**Re: Case No. 21-36-EL-BGN** - In the Matter of the Application of Marion County Solar Project, LLC for a Certificate of Environmental Compatibility and Public Need to Construct a Solar-Powered Electric Generation Facility in Marion County, Ohio.

**Response to First Data Request from Staff of the Ohio Power Siting Board**

**MARION COUNTY SOLAR PROJECT, LLC 'S**  
**RESPONSE TO THE FIRST DATA REQUEST**  
**FROM THE STAFF OF THE OHIO POWER SITING BOARD**

Title  
**Source Water Protection Areas and  
Corridor Management Zones Map**

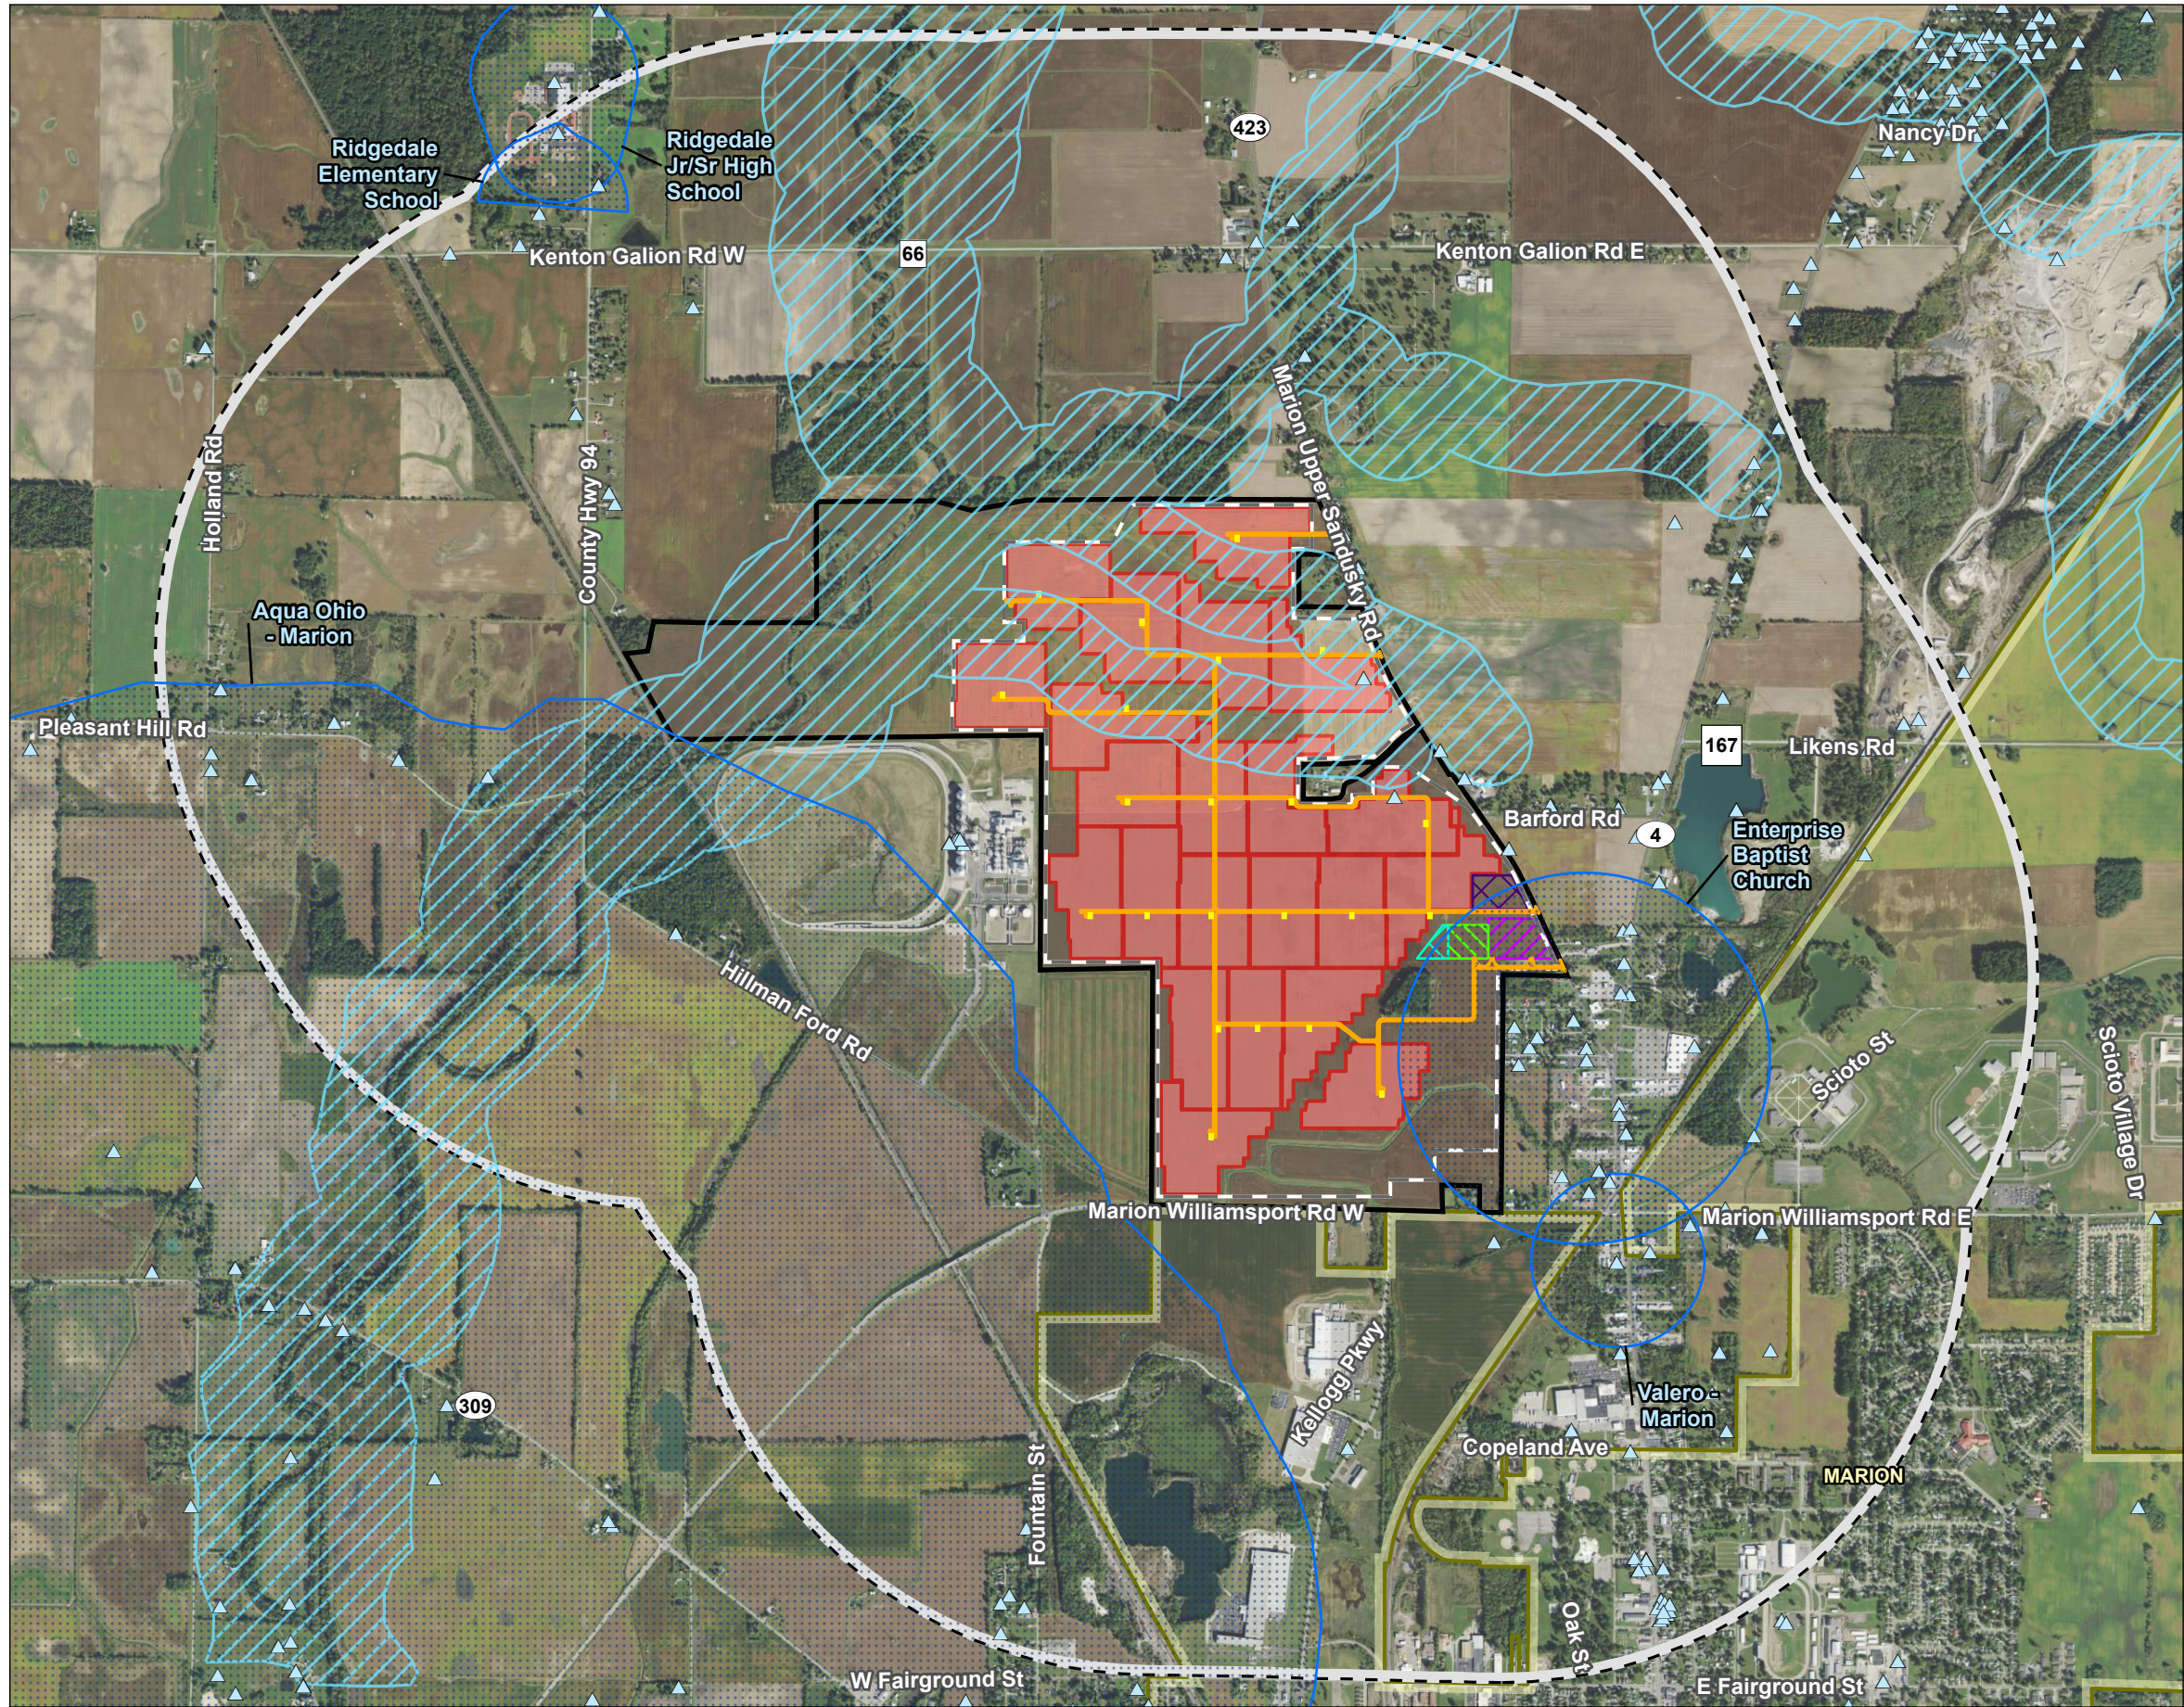
1. **Pg 55 of the application identifies five ground water sourced public water supplies within one mile of the project area. The Applicant concludes that potential impact is unlikely given the depth of the ground water relative to anticipated construction depths. However, the application doesn’t specifically identify the two source water area watersheds or the corridor management zone surface waters located within or immediately adjacent to the project area. Please account for these resources and provide any additional measures that may be considered during construction and operation that will ensure minimal impact.**

**Response:** The ground water sourced public water supplies within one mile of the Project Area (Aqua Ohio - Marion, Enterprise Baptist Church, Valero - Marion, Ridgedale Elementary, and Ridgedale Jr./Sr. High School source water protection areas [“SWPAs”]) are all located within the Columbus Public Water System source water area watershed.

Attachment 1 to this response includes the corridor management zone surface waters in addition to the drinking water source protection areas.

### Battery Energy Storage System Layout

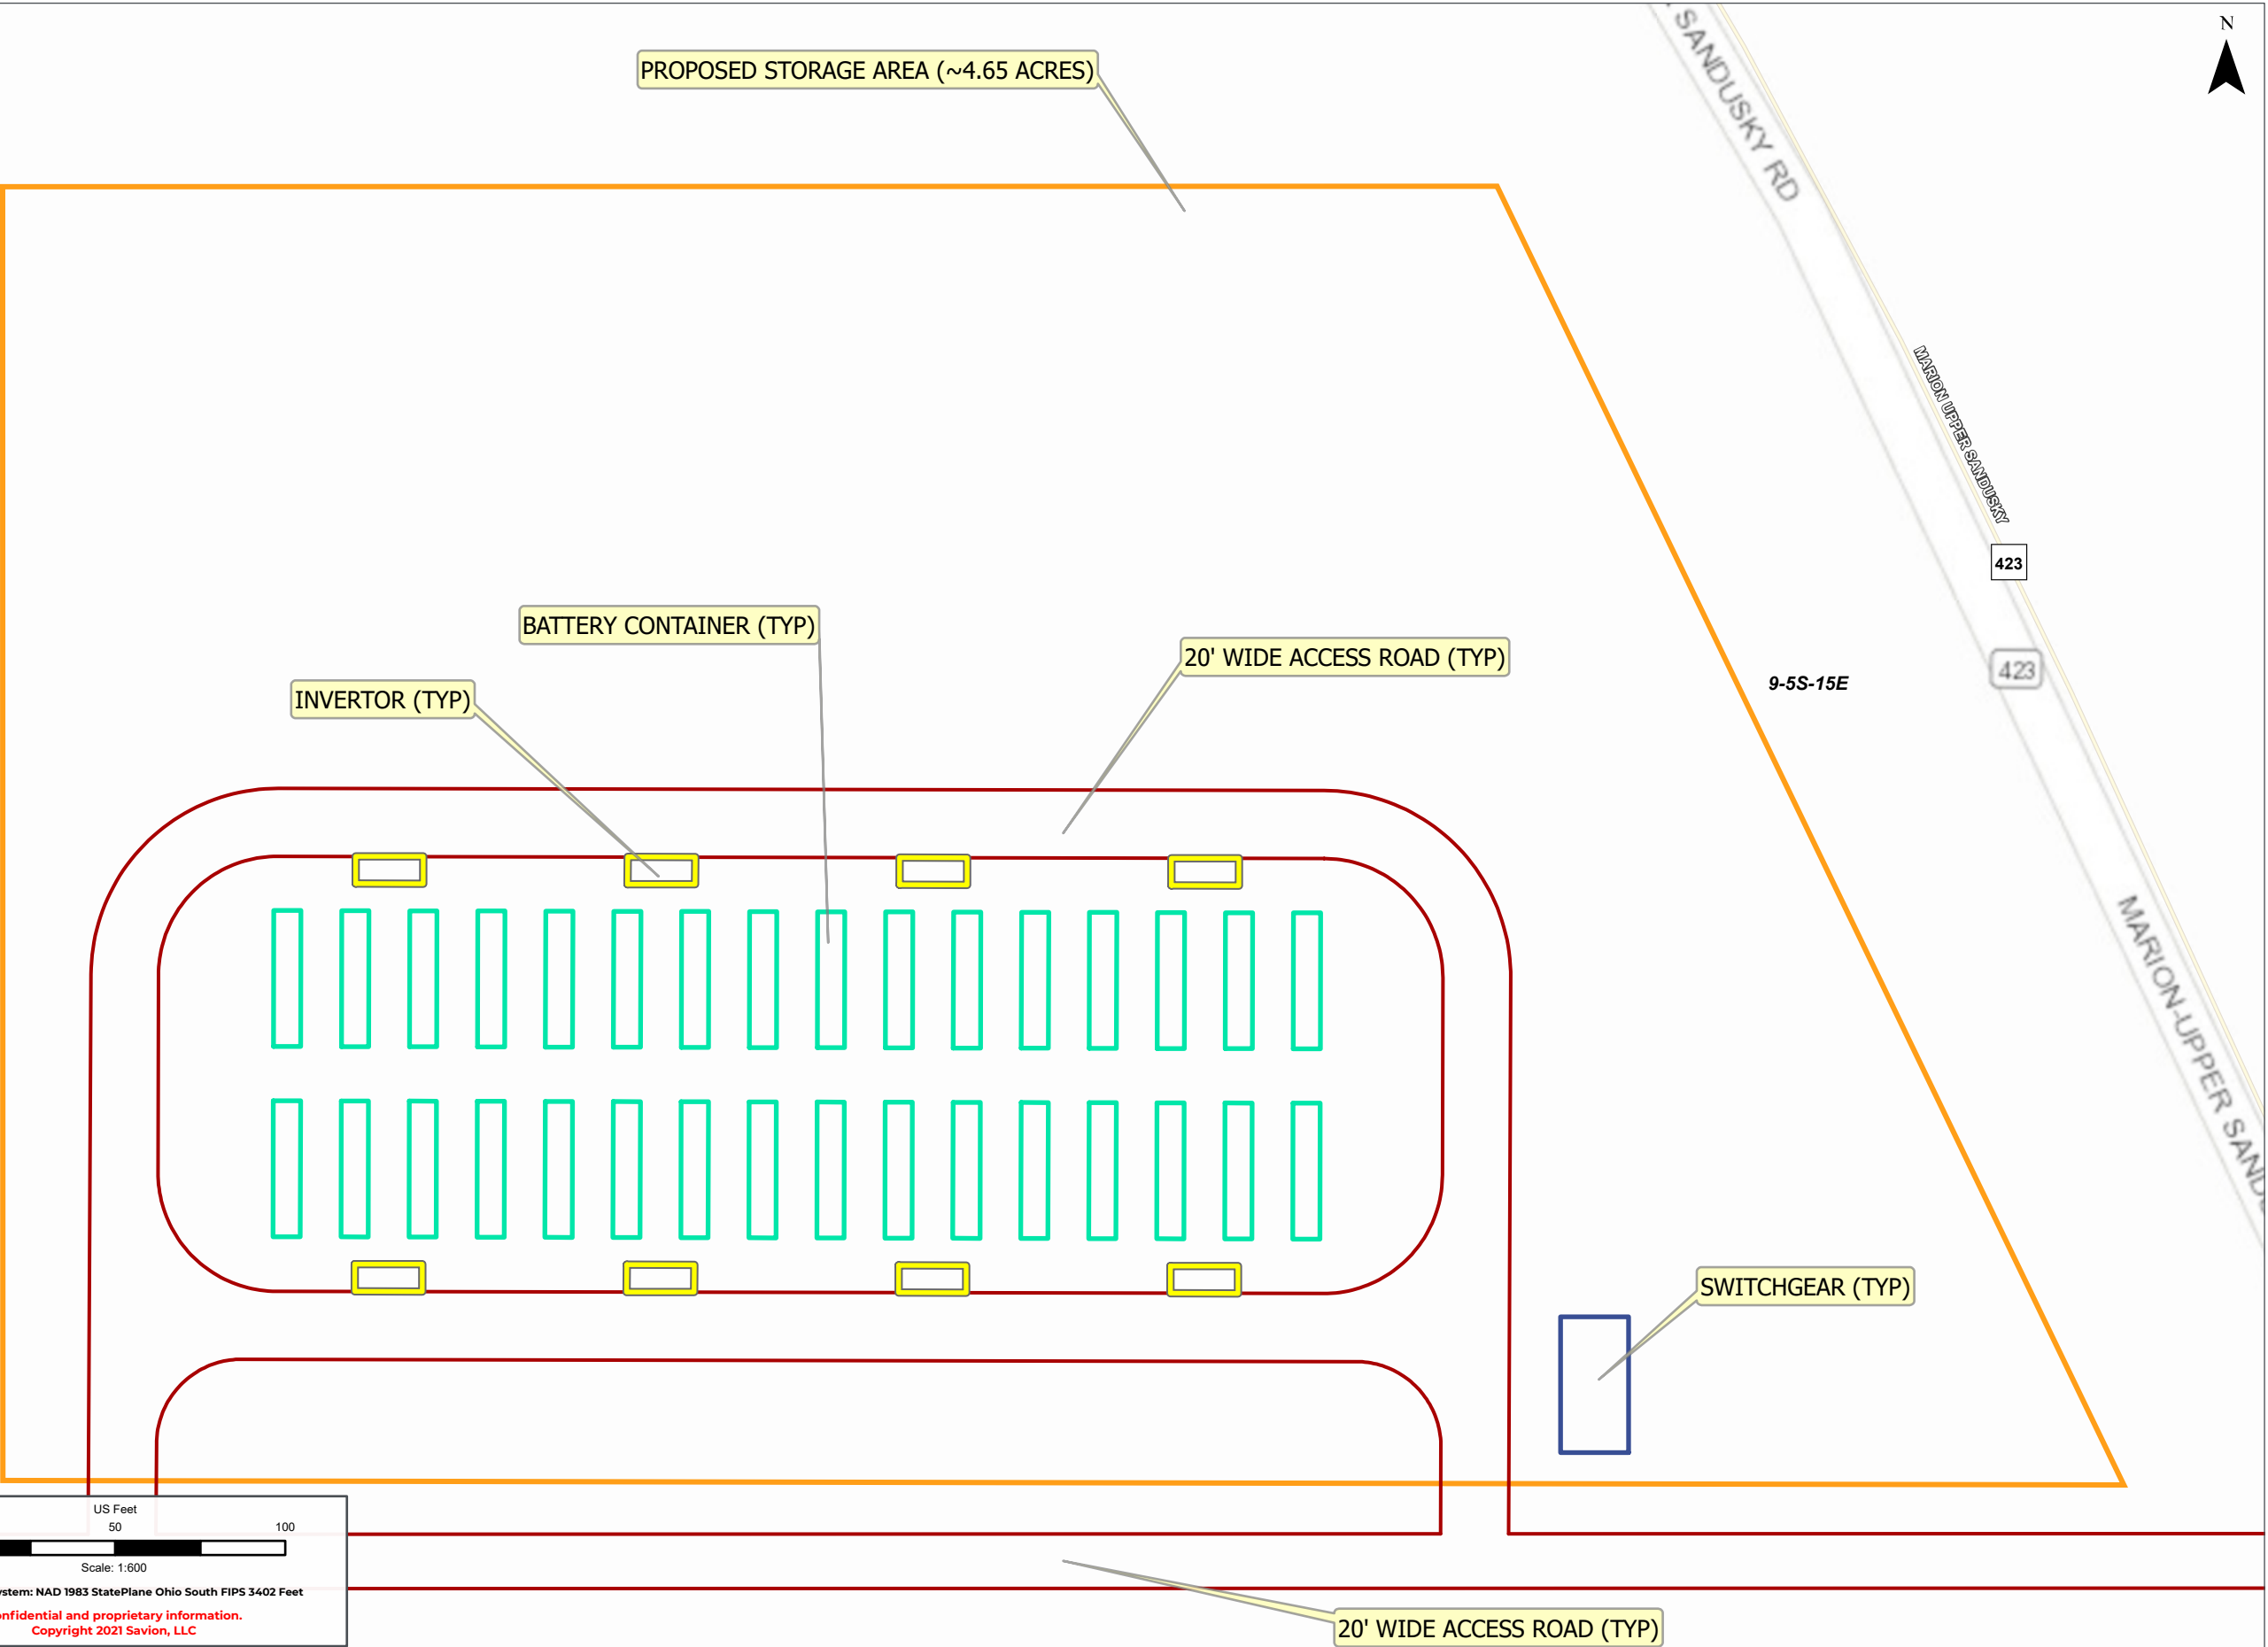
8. **Page 1-1 of Exhibit Q, Sound Level Assessment Report, and page 53 of the Application indicate that the project would use 32 battery containers. Please provide the proposed layout upon which the Sound Level Assessment Report relied.**

**Response:** The proposed layout for the battery energy storage system (“BESS”) is provided as Attachment 2 to this response. This is the proposed layout upon which the Sound Level Assessment Report, Application Exhibit Q, relied.
